WEST SUSSEX COUNTY COUNCIL CONSULTATION

TO:	Mid Sussex District Council FAO: Joseph Swift
FROM:	Stephen Gee WSCC – Highways Authority
DATE:	3 December 2025
LOCATION:	Burgess Hill Northern Arc, Land N And NW Of Burgess Hill, Between Bedelands Nature Reserve In The East And, Goddard's Green Waste Water Treatment Works In The West
SUBJECT:	DM/25/2640 Reserved matters application to consider access, appearance, landscaping, layout and scale pursuant to application DM/21/3279 (original reference DM/18/5114) for parcel P1.2 comprising of the construction of a primary school with nursery and special support centre, car parking, multi-use games area, playing fields, landscaping and associated infrastructure.
DATE OF SITE VISIT:	16/10/2025
RECOMMENDATION:	More Information

Figure 1 Highways Agreement Drawing extract

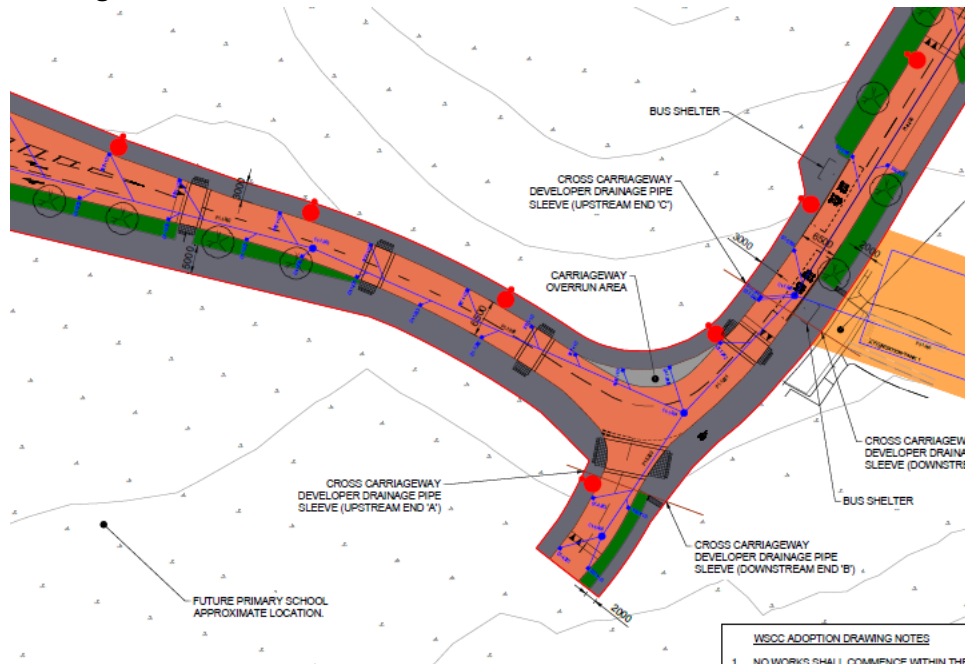
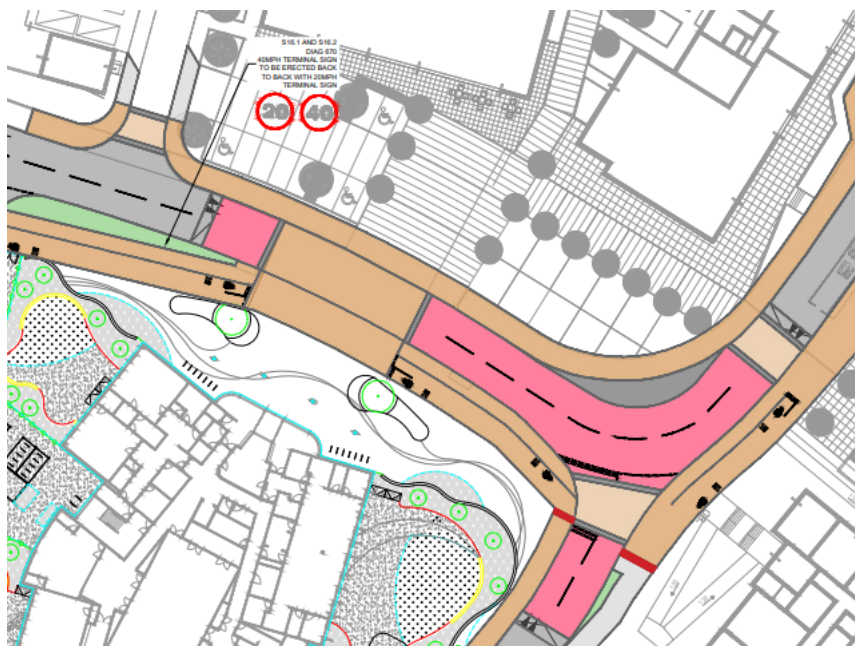
The application proposes amendments to the EBLR from the approved highway agreements drawings shown below

A wide pedestrian crossing point is proposed to the to link the proposals to the neighbourhood square. The crossing will be demarcated by a change in materials. No formal priority is provided to those crossing.

No parking restrictions are shown on the EBLR either and as such there is the potential for vehicles to stop and drop off or park in the carriageway. It is recommended that a scheme of monitoring and potential measures to restrict parking are identified.

The plans also show the removal of the crossing point closest to the bend and introduce a break in the green super highway. A Stage 1 Road Safety Audit should be provided for the changes.

Concern is raised about the interaction of waiting parents and school children, the Green Cycle and the operation of the EBLR (Holmbush Avenue) . Bollards are shown on the visuals provided e.g Design Principles Statement 2084-SFS-X-00-RP-A-DPS-P03

Evidence should be provided to demonstrate that the proposed set back of the school is sufficient to accommodate the likely demands of parents (especially at pick up time).

Consideration should also be provided to the suitability of providing a level of formal control for pedestrians across the EBLR.
